Date: August 28, 2015
Project No.: 535-1-3
Prepared For: Mr. Ed Abelite
CANYON CREEK PLAZA, LP
5601 Silver Creek Valley Road
San Jose, California 95136
Re: Geotechnical and Geologic Hazards Report Update
Canyon Creek Plaza
5601 – 5667 Silver Creek Valley Road
San Jose, California

This letter is to update our previous geologic and geotechnical reports. We have been provided with a set of plans titled “Planned Development Plan “Exhibit C”, Canyon Creek Plaza, New Retail/Commercial Building to Existing Shopping Center, 5601-5667 Silver Creek Valley Road” prepared by LPMD Architects, and dated June 3, 2015.

Project Number	535-1-2
Figure Number	Figure 1
Date	June 2013
Drawn By	RRN

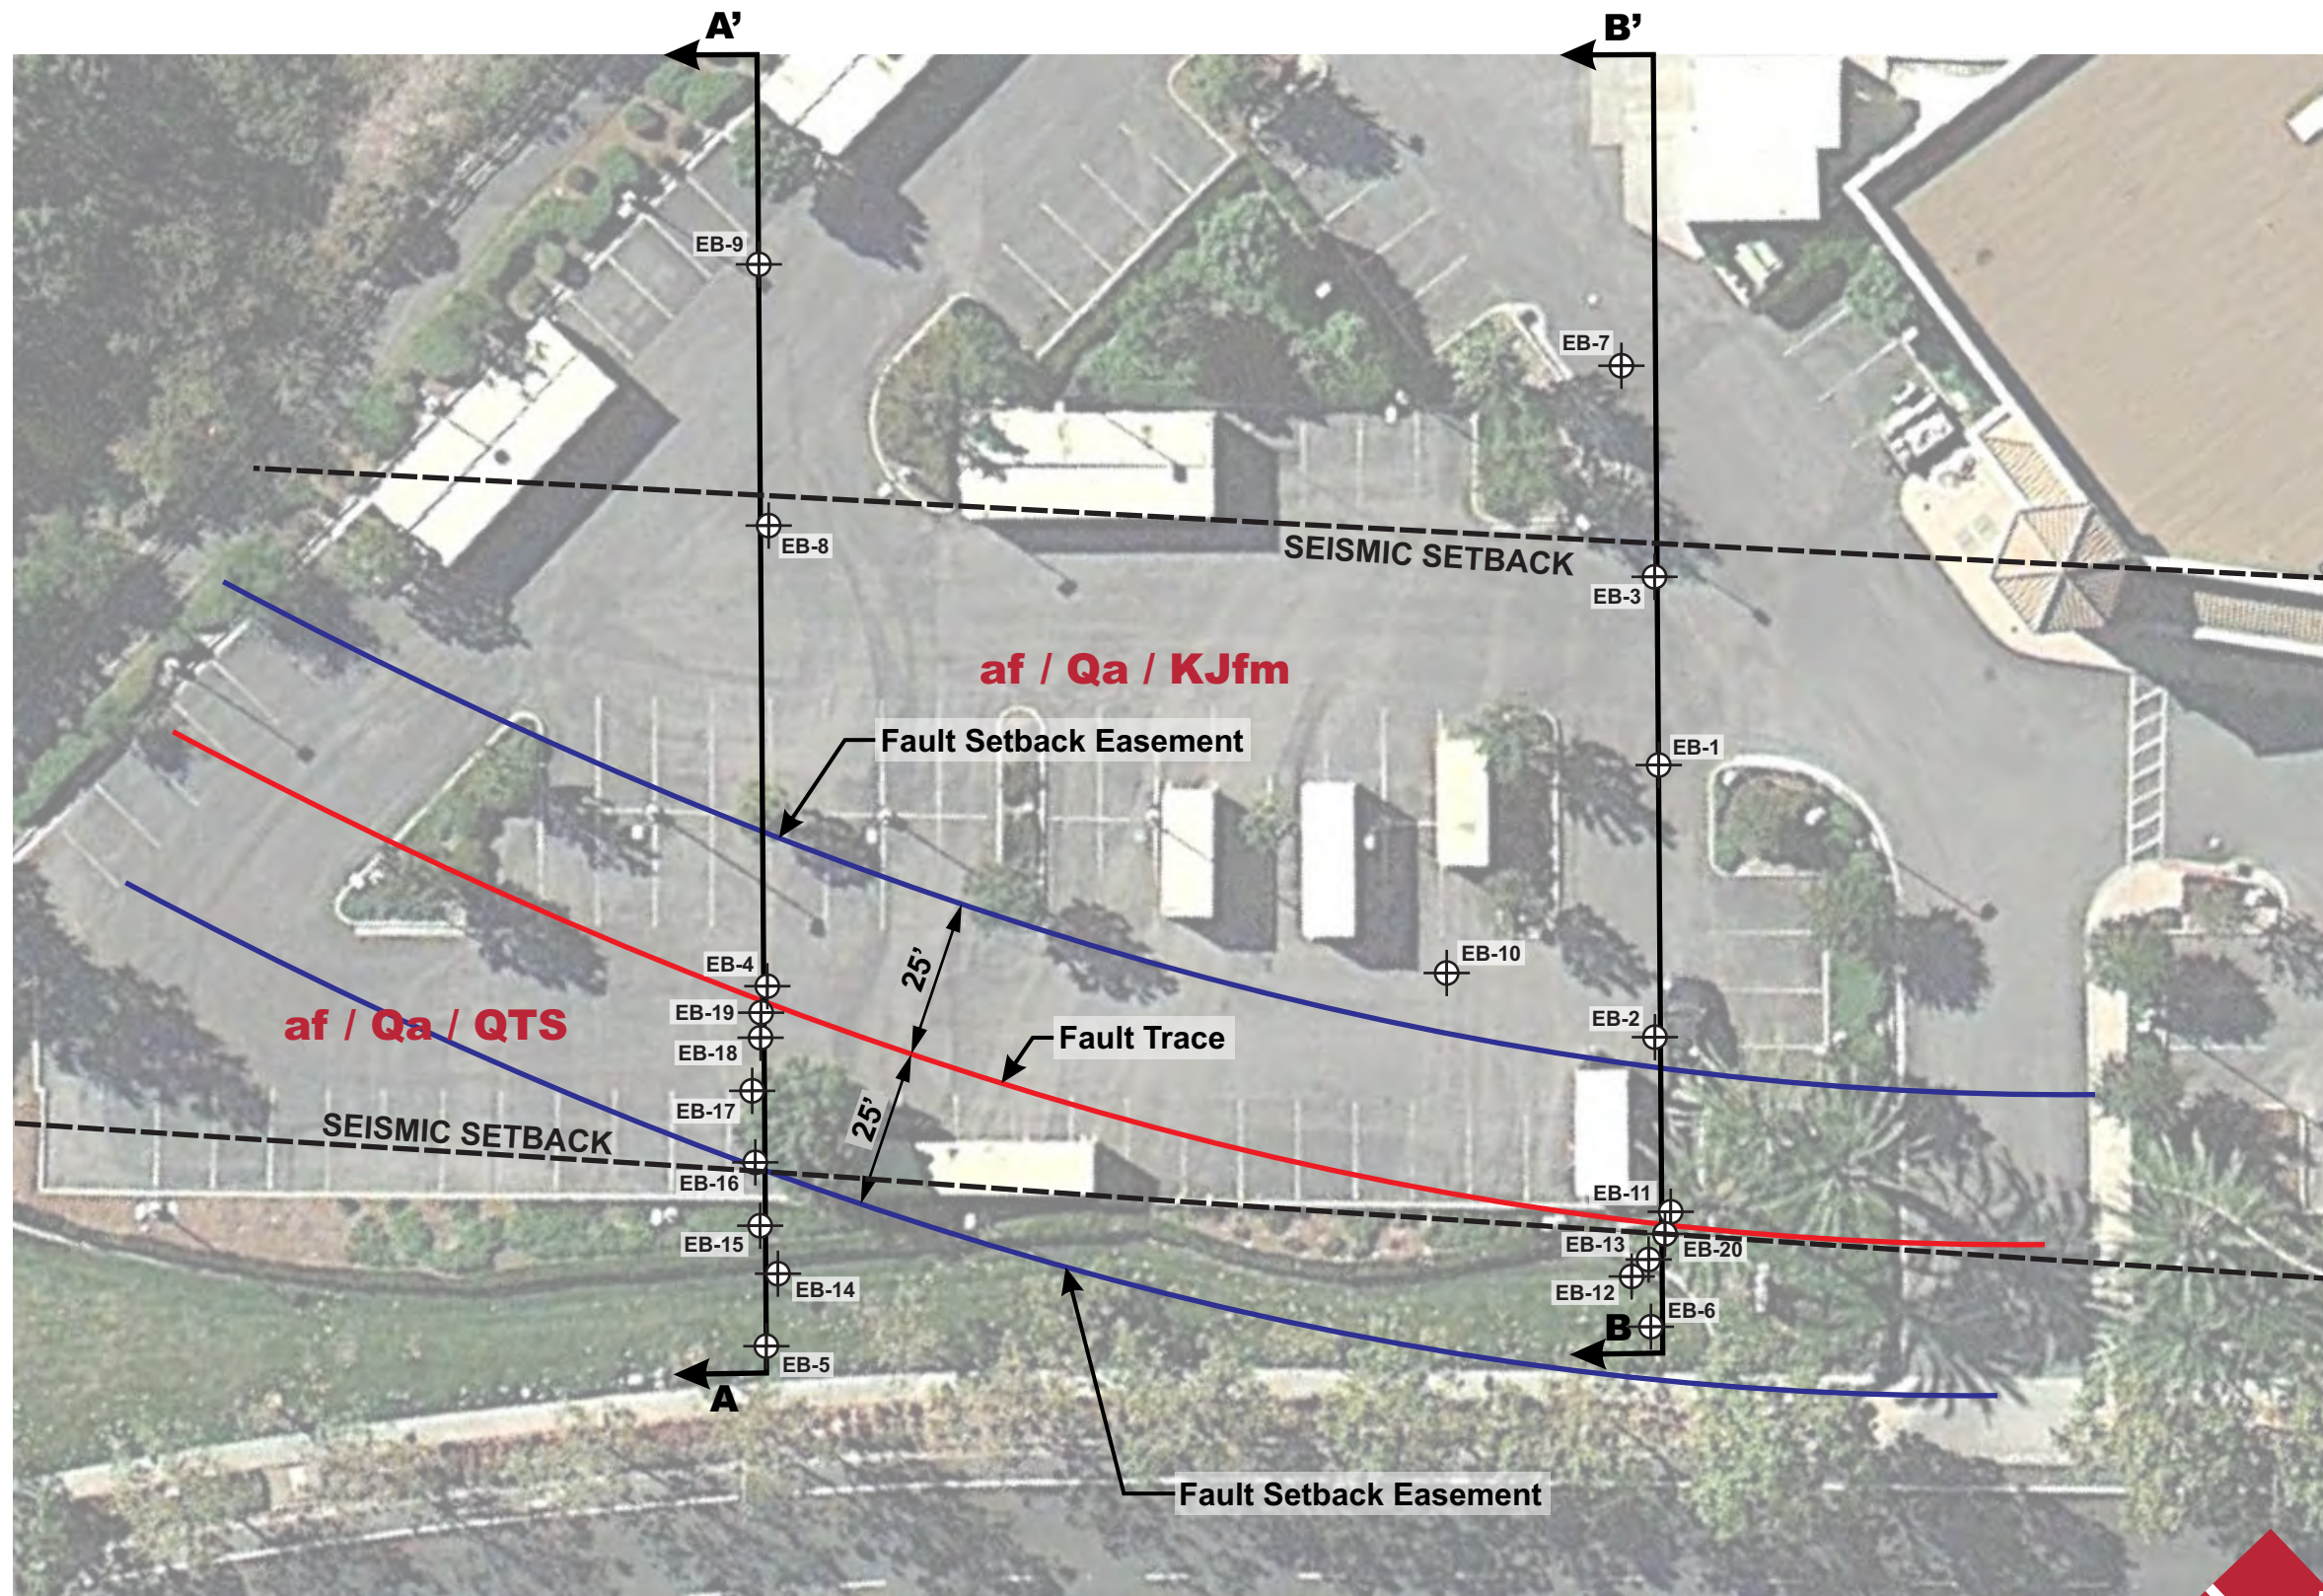
DPW Comment #4: “On p.10 in the discussion of the Terrasearch study, “the SSE” is stated to be shown on Figure 2, however, this figure only shows the new recommended CEG SSE, not the original existing TI (1988) SSE. This statement should be clarified.”

CEG Response to DPW #4: The SSE of TI (1988) is actually shown as a black dashed line and labeled “Seismic Setback” on Figure 1 in our report (refer to that “Site Plan”).

Project Number 535-1-2	Figure Number Figure 4	Date July 2014	Drawn By RRN
Geologic Cross Section A-A'			
Canyon Creek Plaza 5601 Silver Creek Valley Road San Jose, CA

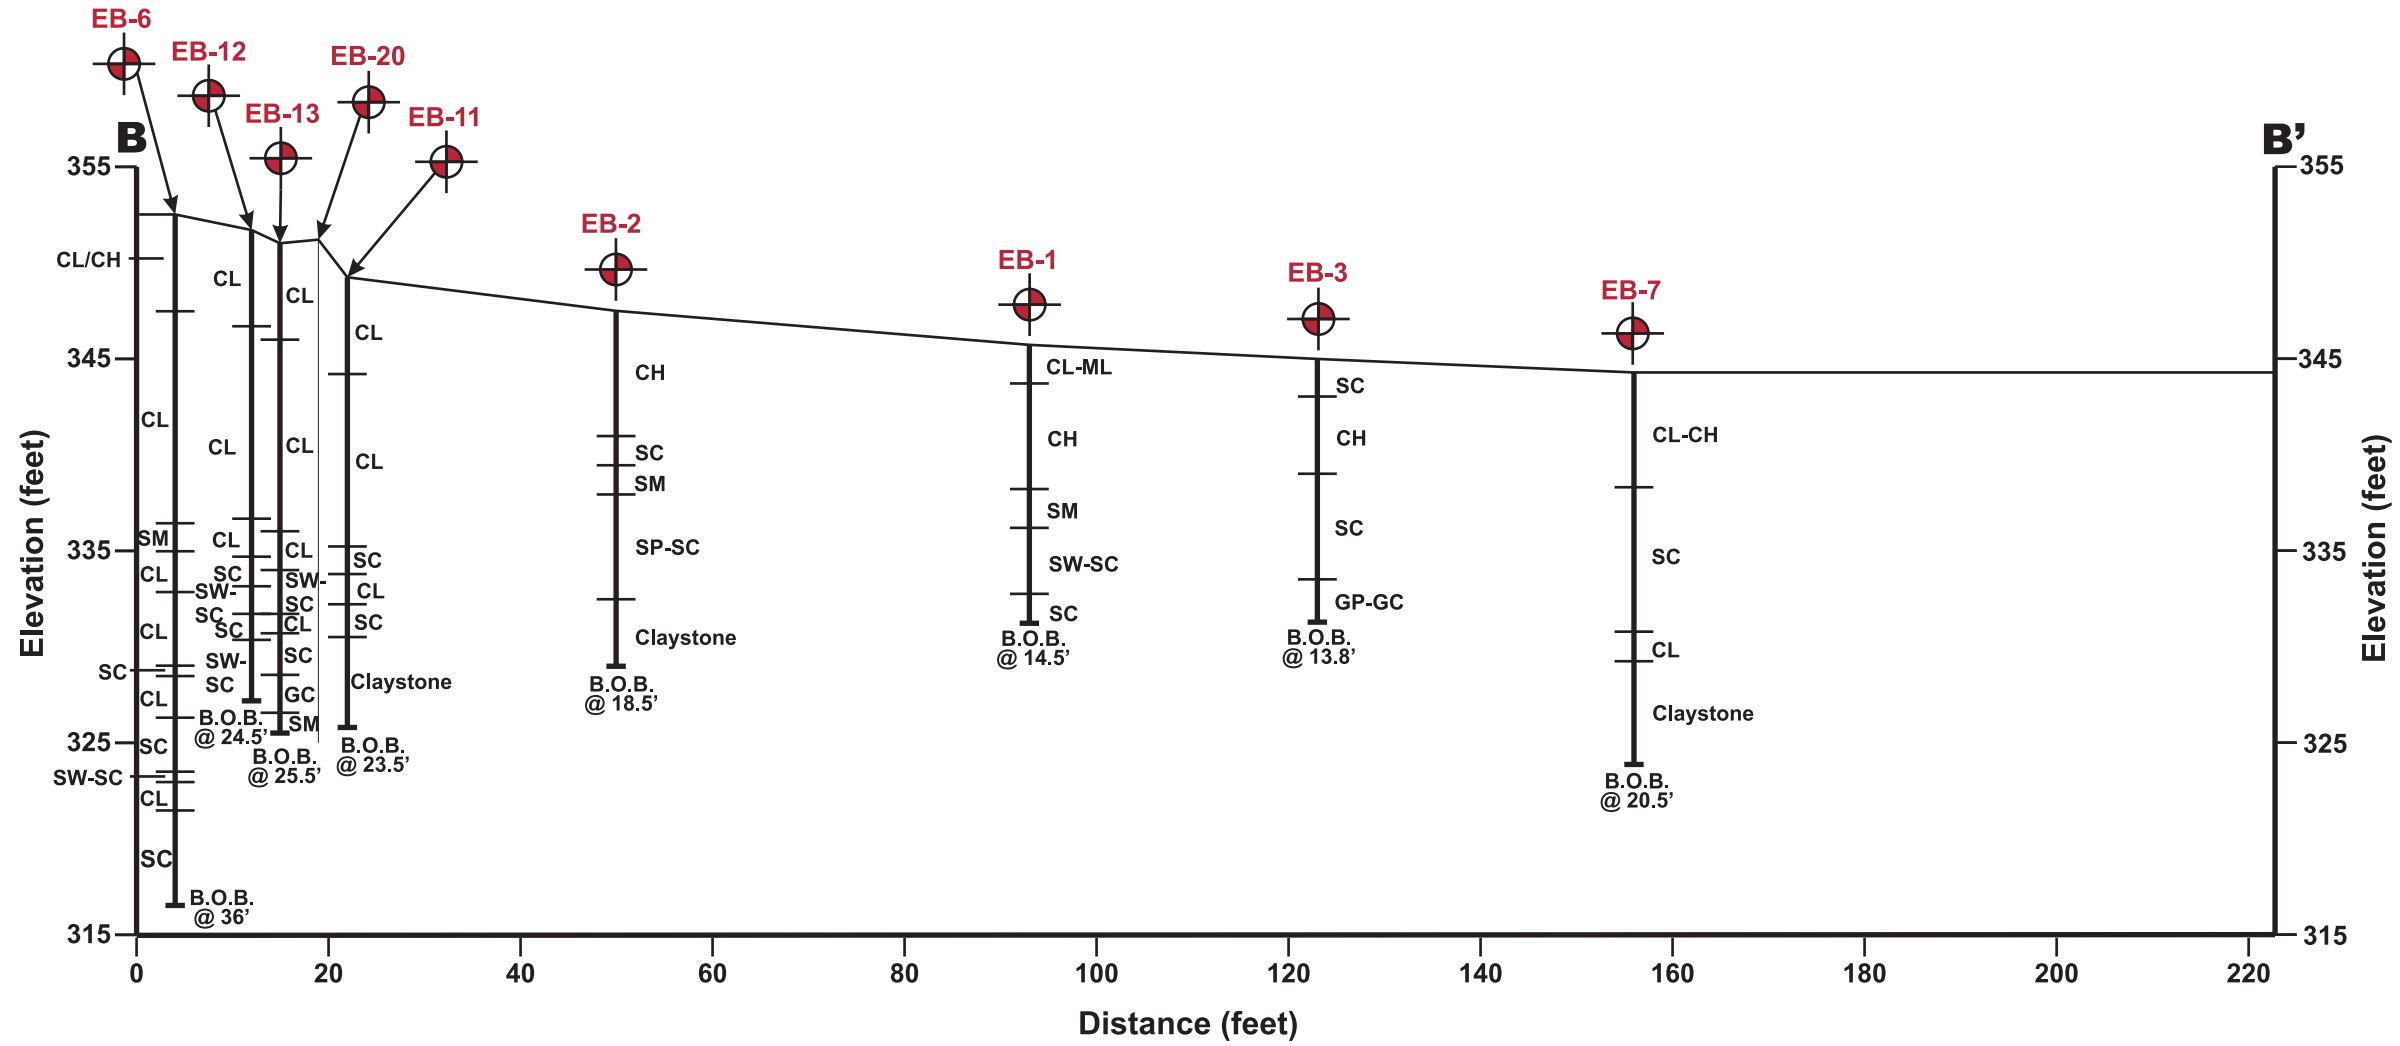
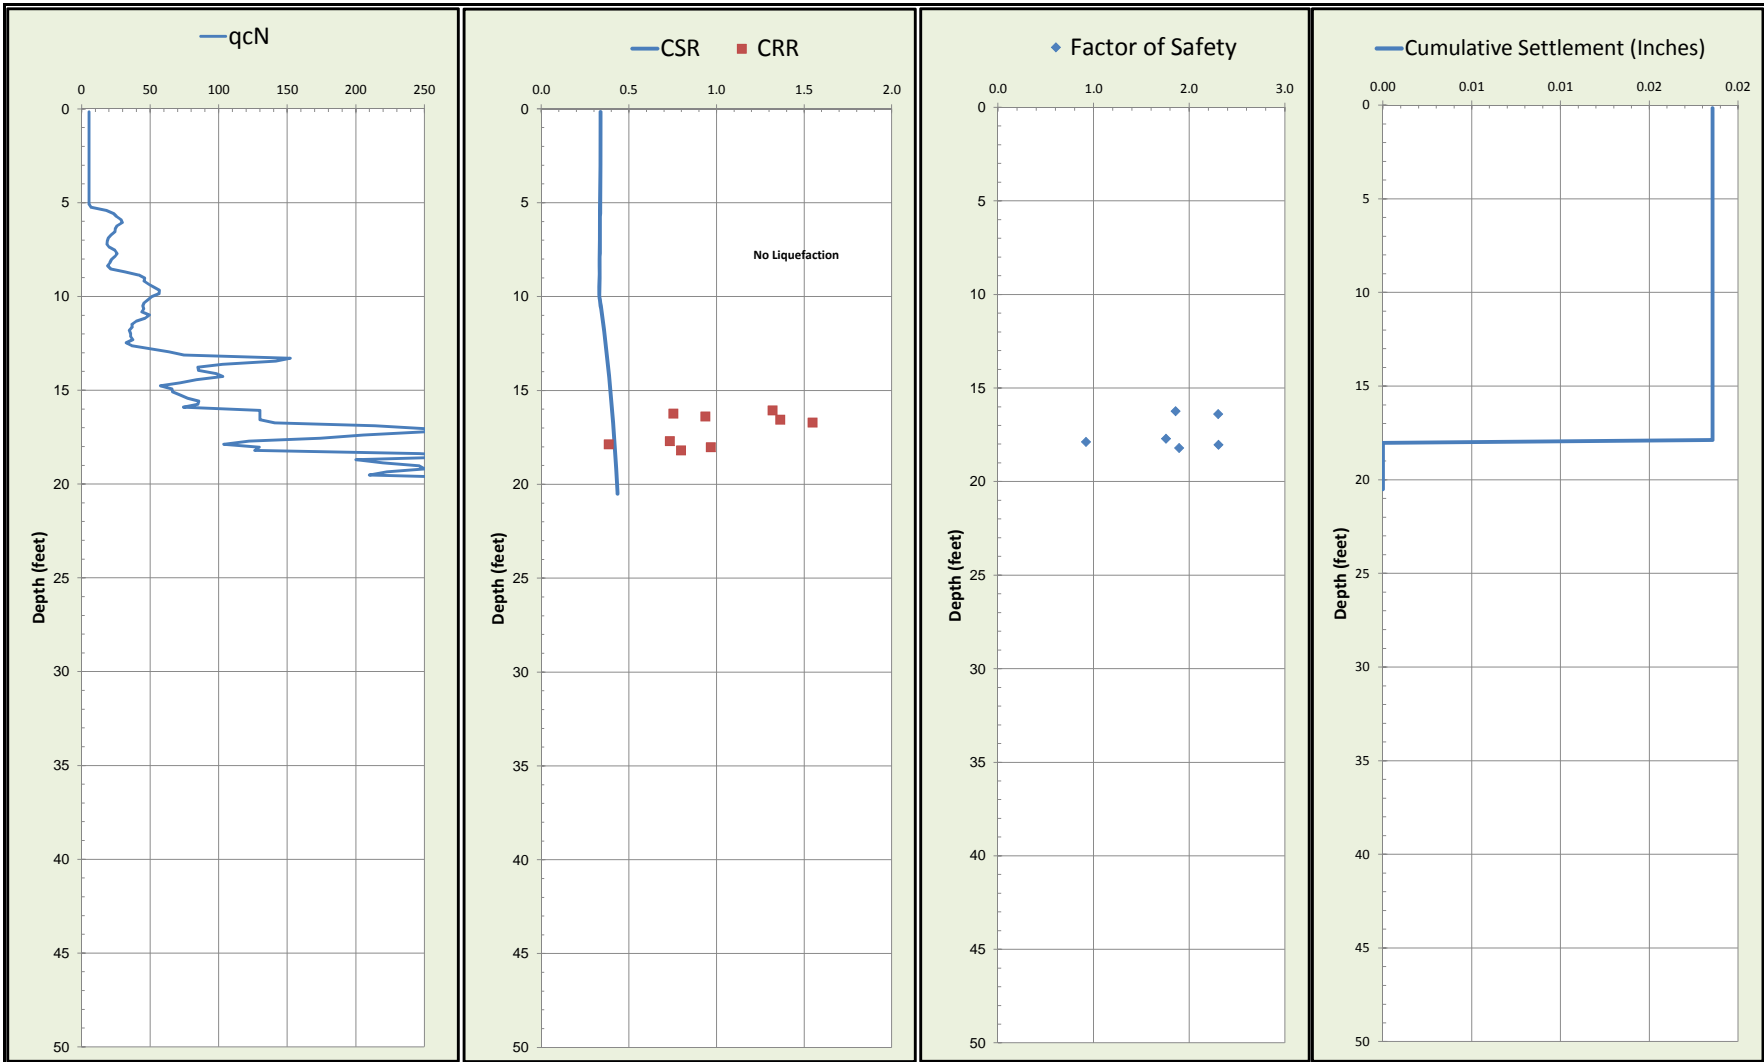
DPW Comment #13: “The location of the SCF is not evident in Geologic Cross Sections A-A' or B-B', Figures 4 and 5. Supplemental cross sections showing the CEG SCF, the TI (1988)/KI(1989) SCF location, groundwater levels, soil stratigraphic lines, overlying alluvium/colluvium deposits, the buried bedrock surface, offsets in the bedrock surface and juxtaposition of differing bedrock formations should be presented.”
